# Work Order ID 71113

Item Name: Basket Hoop

DESIGN #	DRAWN BY CP	DART AEROSPACE LTD HAWKESBURY, ONTARIO, CANADA	
CHECKED #	APPROVED #	DRAWING NO. D3166	REV. A SHEET 1 OF 1
DATE 02.07.10		TITLE BASKET HOOP	SCALE NTS
A	02.07.10	NEW ISSUE	
A1	CP 04.04.08	38+-1 WAS 36.0

DRAWING NO. D3166	TITLE BASKET HOOP	REV A1	DART AEROSPACE LTD ENGINEERING ORDER		D.E.O. NO. D3166-A-2	SHEET NO. 1 OF 1	SCALE NTS
DRAWN AJS	CHECKED	MFG. APPR.	APPROVED		DE APPR.		
DATE 08.12.11	DATE 08.12.15	DATE 08/12/15	DATE 08/12/16		DATE 08.12.16

D3166-1 BASKET HOOP

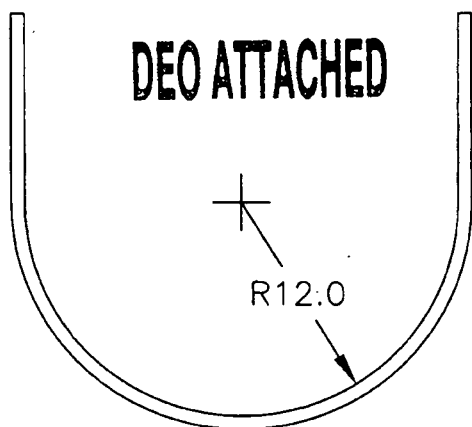
10.6 (REF, NEED 8.0 MIN)

1) MODIFY MATERIAL NOTE FOR D3166-1 AS SHOWN:

- 1) MATERIAL: AISI 304/316 SS SQUARE TUBING,  
0.75" x 0.75" x 0.063 WALL, 60.00" LONG  
(REF DART SPEC. M304TS0.750W.063)

- 1) MATERIAL: AISI 304/316 SS, 3/4 X 3/4 X 0.065 WALL SQUARE TUBING,  
60.00" LONG  
REF. DART SPEC M304TS0.750W.065

D3166-3 BASKET HOOP

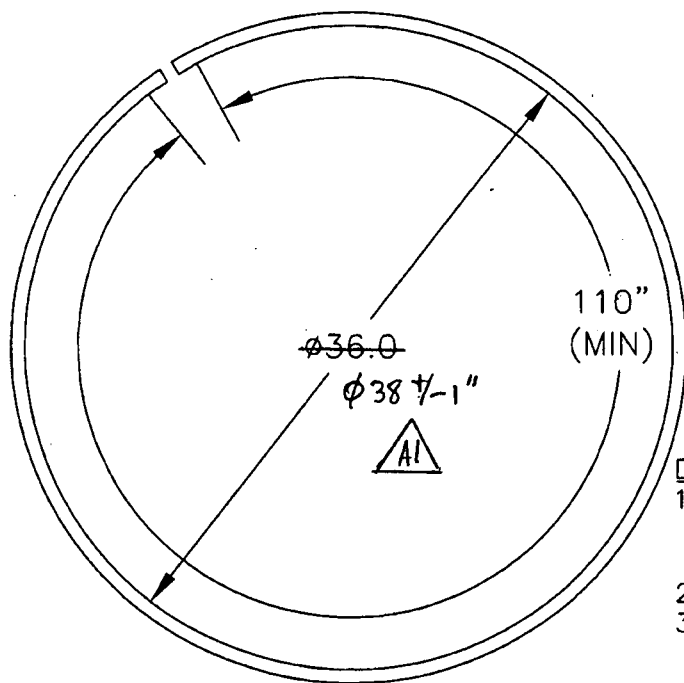
2) MODIFY MATERIAL NOTE FOR D3166-3 AS SHOWN:

- 1) MATERIAL: AISI 304/316 SS SQUARE TUBING,  
0.75" x 0.75" x 0.063 WALL, 120.00" LONG  
(REF DART SPEC. M304TS0.750W.063)

- 1) MATERIAL: AISI 304/316 SS, 3/4 X 3/4 X 0.065 WALL SQUARE TUBING,  
120.00" LONG  
REF. DART SPEC M304TS0.750W.065
